Subject: Implementation of PRIME Models and Data in Downstream Methods, NEDO-33173, Supplement 4-A, September 2011

IMPLEMENTATION OF PRIME MODELS AND DATA IN DOWNSTREAM METHODS

SUBJECT: FINAL SAFETY EVALUATION FOR GE HITACHI NUCLEAR ENERGY AMERICAS TOPICAL REPORT NEDO-33173, SUPPLEMENT 4, "IMPLEMENTATION OF PRIME MODELS AND DATA IN DOWNSTREAM METHODS" (TAC NO. ME1704)

APPENDIX L – SAFETY EVALUATION OF SUPPLEMENT 4 TO NEDO-33173

Figure 1: ECCS/LOCA Evaluation Model Process Diagram (Reference 8)

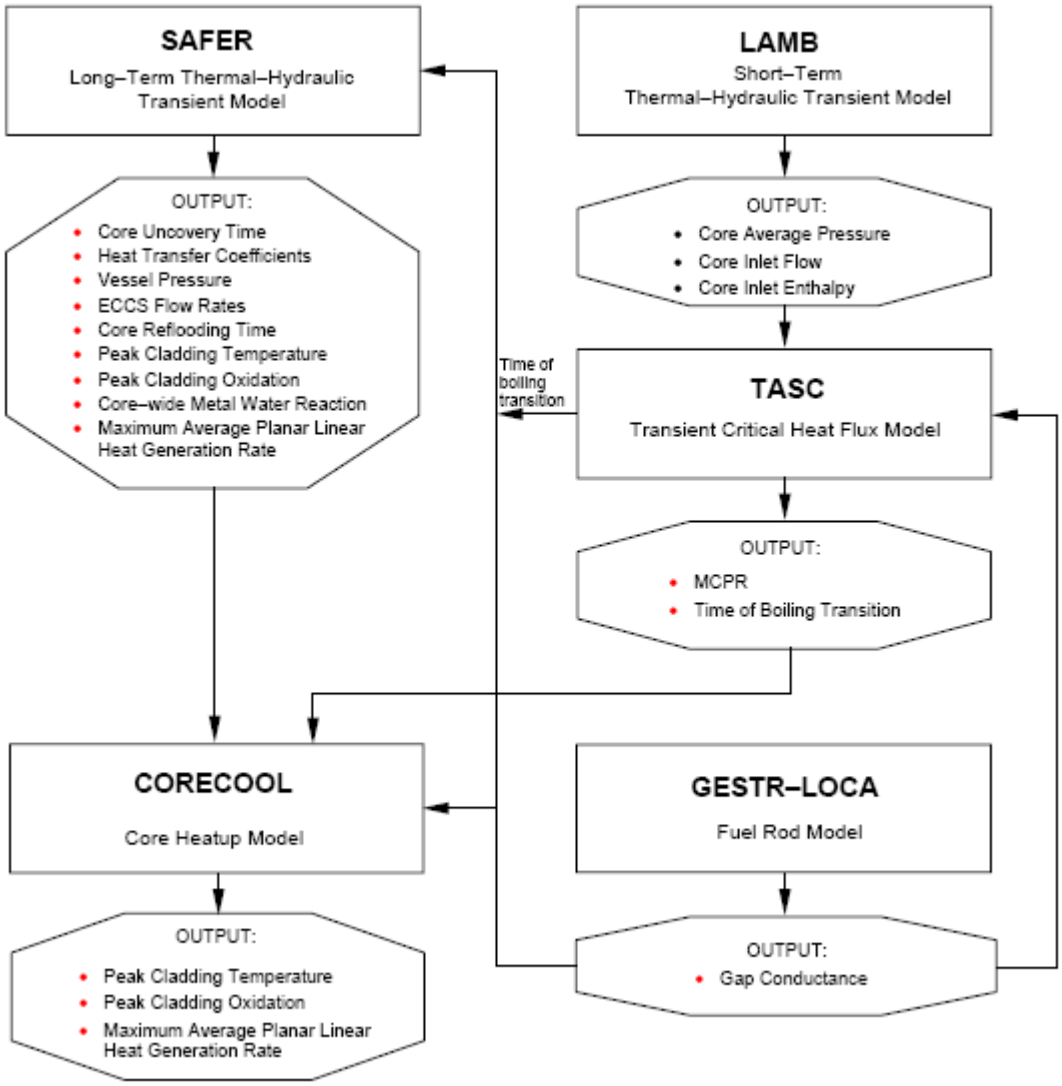
The basis for the Appendix K ECCS/LOCA evaluation model is SAFER/GESTR (Reference 1). The purpose of the SAFER code is to calculate long-term reactor vessel inventory and PCT for LOCA and loss of inventory events. SAFER is intended for use with GSTRM to perform ECCS/LOCA analyses. The various individual codes utilized in the ECCS/LOCA evaluation model are depicted in Figure 1. The GESTR-LOCA fuel rod model mentioned in Figure 1 is equivalent to GSTRM.

Supplement 4 describes one update to the SAFER model. The code will be modified to include an option to select the PRIME-based fuel thermal conductivity model as a function of temperature, exposure, gadolinia concentration, additive concentration, and fraction of theoretical density. Inputs to the SAFER code may provide a full description of the fuel initial conditions and are therefore sufficient to drive the PRIME-based model in the ECCS/LOCA calculations. The NRC staff finds this acceptable.

The CORECOOL code (CORCL) is used to perform PCT calculations under conditions of spray cooling during LOCA simulations (References 26 and 27). Information to run CORCL is typically provided by SAFER calculations through interface files in the standard analysis process. As a consequence of this linkage, gas gap conductance information from SAFER is passed directly to CORCL. Therefore, no modifications are required for CORCL to account for the PRIME-based gap conductance models given the changes to the SAFER input described above.

Several options exist within CORCL to model the fuel thermal conductivity. In the approach described in Supplement 4, CORCL will be modified with an option to select the PRIME-based fuel thermal conductivity as a function of temperature, exposure, gadolinia concentration, additive concentration, and fraction of theoretical density. The NRC staff finds that this approach is acceptable.
